NW MAIN PUMP STATION

RE: SUB 2001-13 -- One-Step Final Plat of NW Main Pump Station Addition

RE: SUB 2000-13 -- One-Step Final Plat of NW Main Pump Station Addition

CASE NUMBER: SUB 2001-13 -- NW MAIN PUMP STATION ADDITION

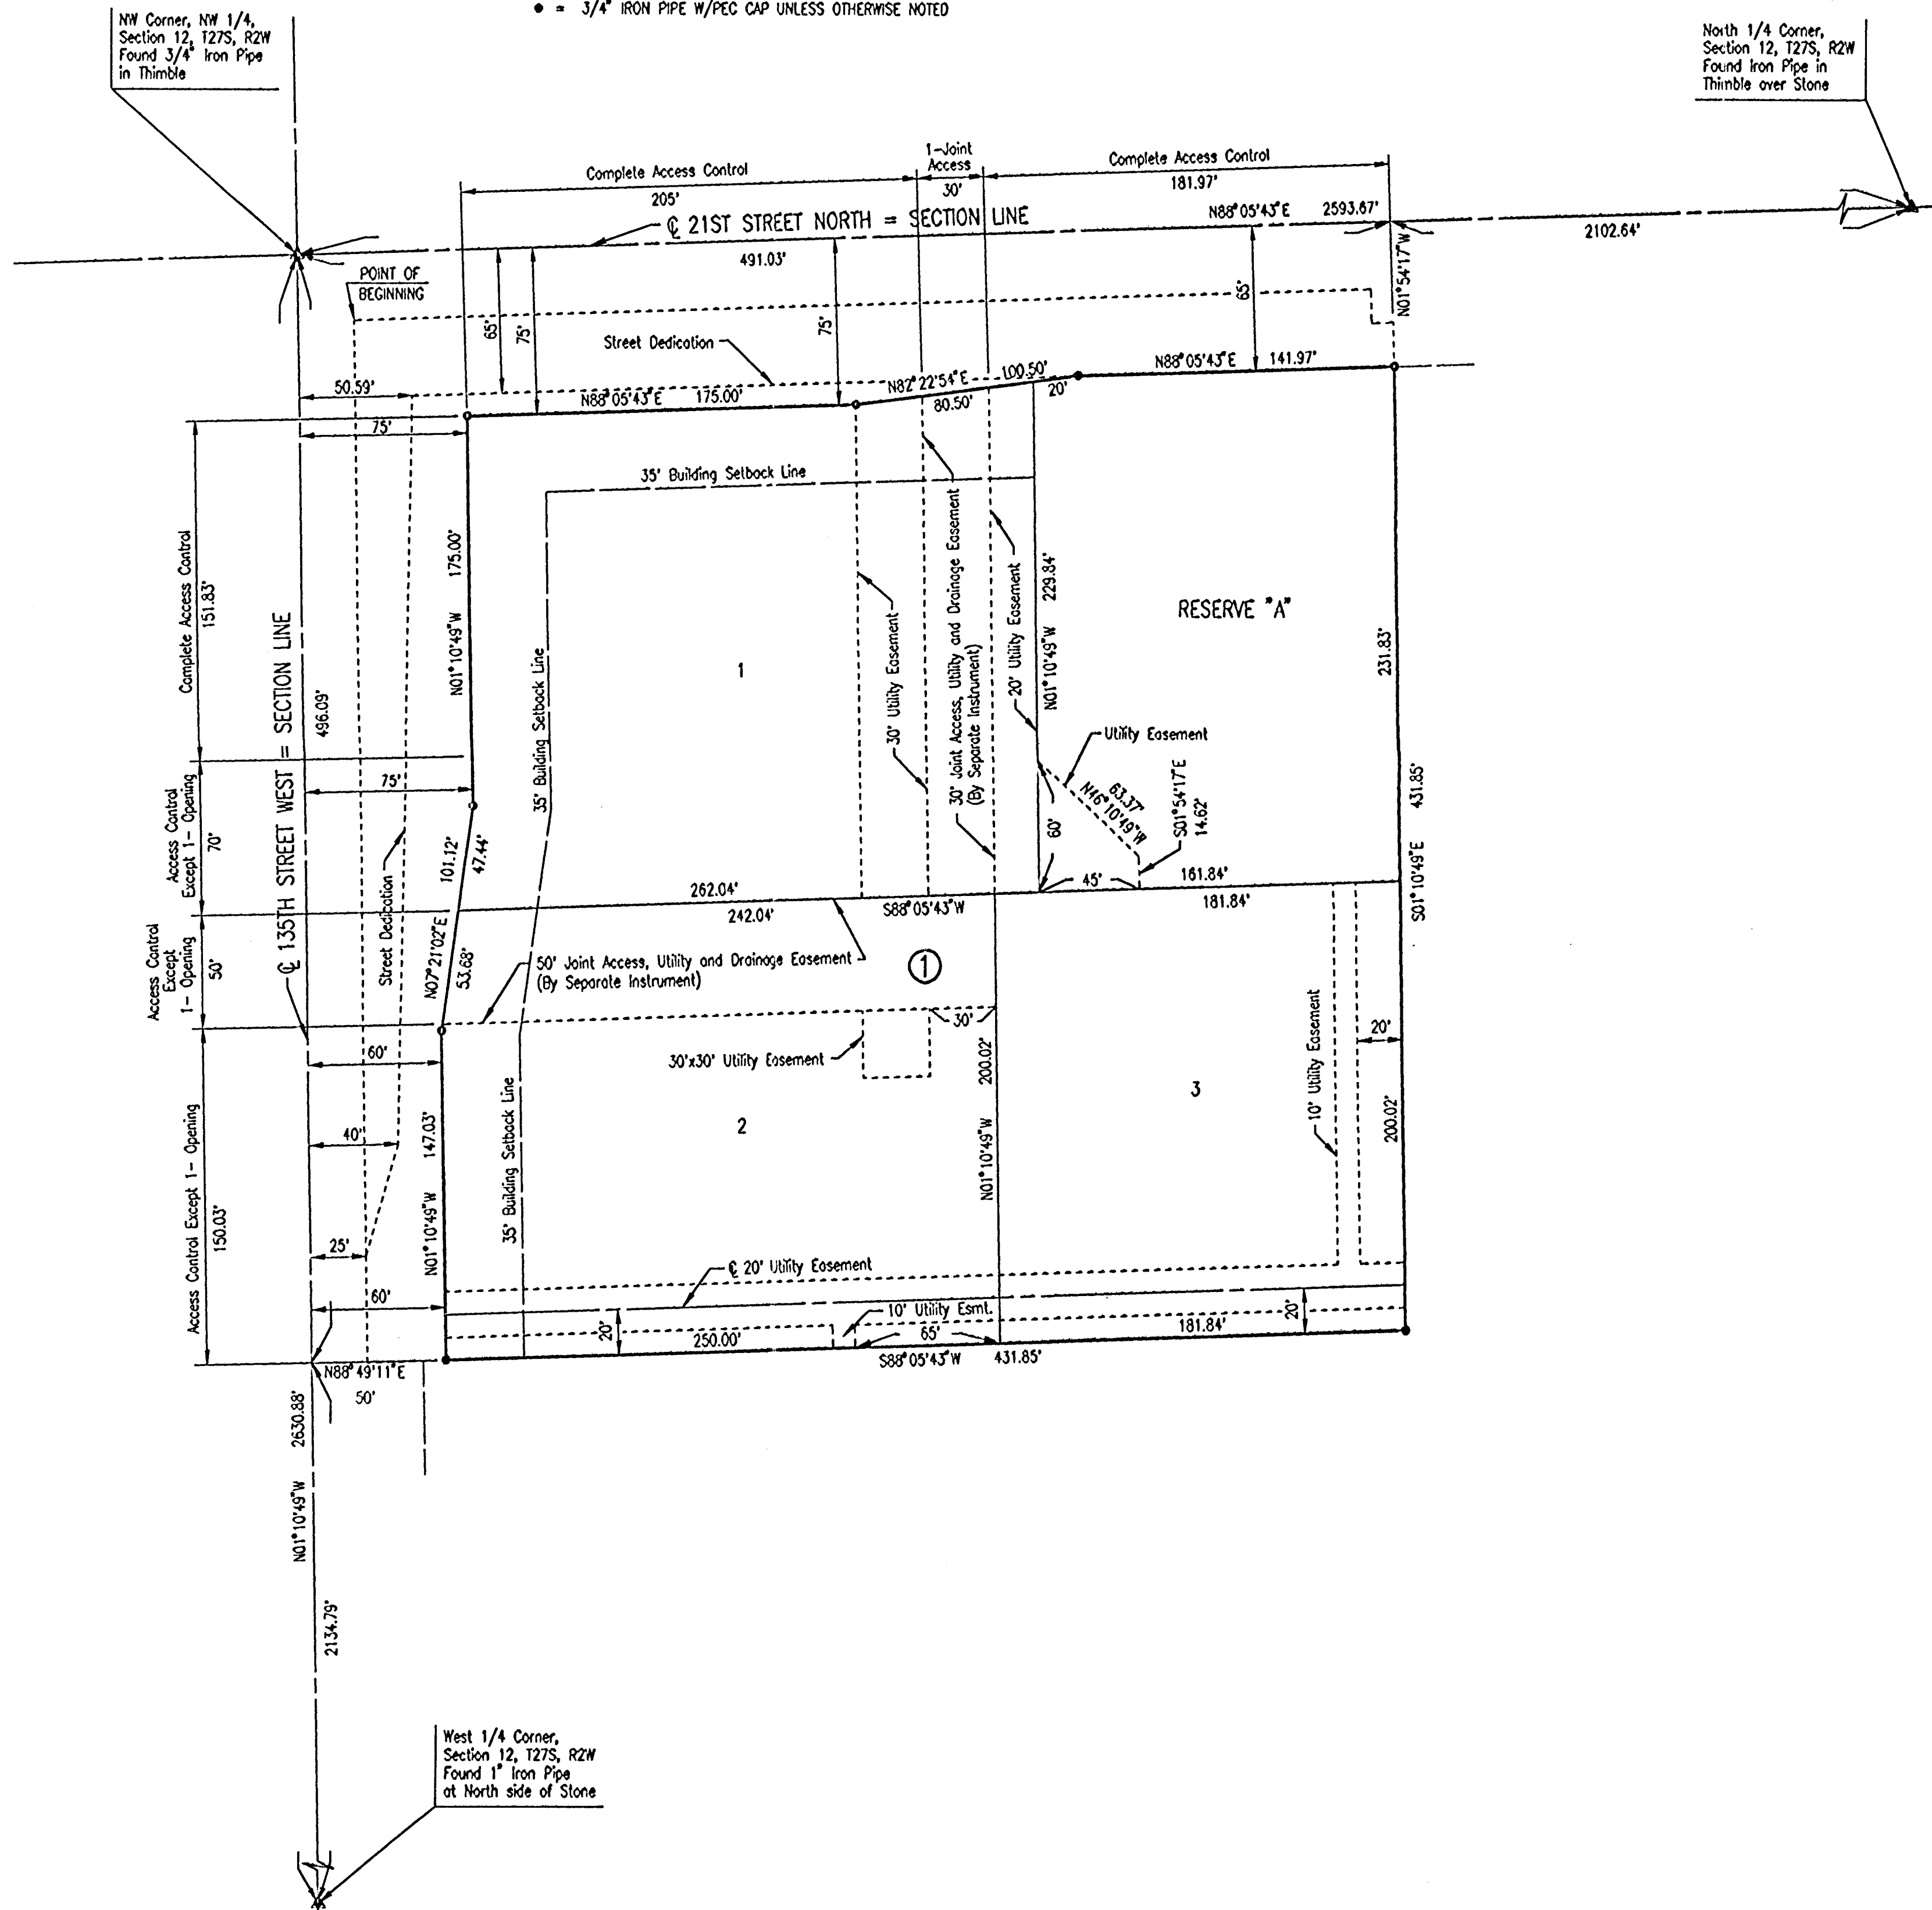
- D. In accordance with the Conditional Use site plan, the plat proposes a joint access along 21st St. North. The Protective Overlay permitted one opening along 135th St. West if Lot 2 was to be zoned LC, and three openings along 135th St. West if Lot 2 was intended for a government service use. As the plat proposes three openings, Lot 2 will remain zoned SF-6 and allow for government services.

- E. The applicant shall guarantee the closure of any driveway openings located in areas of complete access control or that exceed the number of allowed openings.

- F. The access easements platted for the benefit of Lot 3 needs to be established by separate instrument.
- G. Provisions shall be made for ownership and maintenance of the proposed reserves. The applicant shall either form a lot owners' association prior to recording the plat or shall submit a

- I. County Engineering needs to comment on improvements to perimeter streets. The Subdivision Regulations require paved access between the nearest paved segment and the entrance to the plat. *The Applicant shall submit a guarantee for the paving of 135th St. West to the south line of the plat.*

- L. The platator's text shall include language that a drainage plan has been developed for the plat and that all drainage easements, rights-of-way, or reserves shall remain at established grades or as modified with the approval of the applicable City or County Engineer, and unobstructed to allow for the conveyance of stormwater.
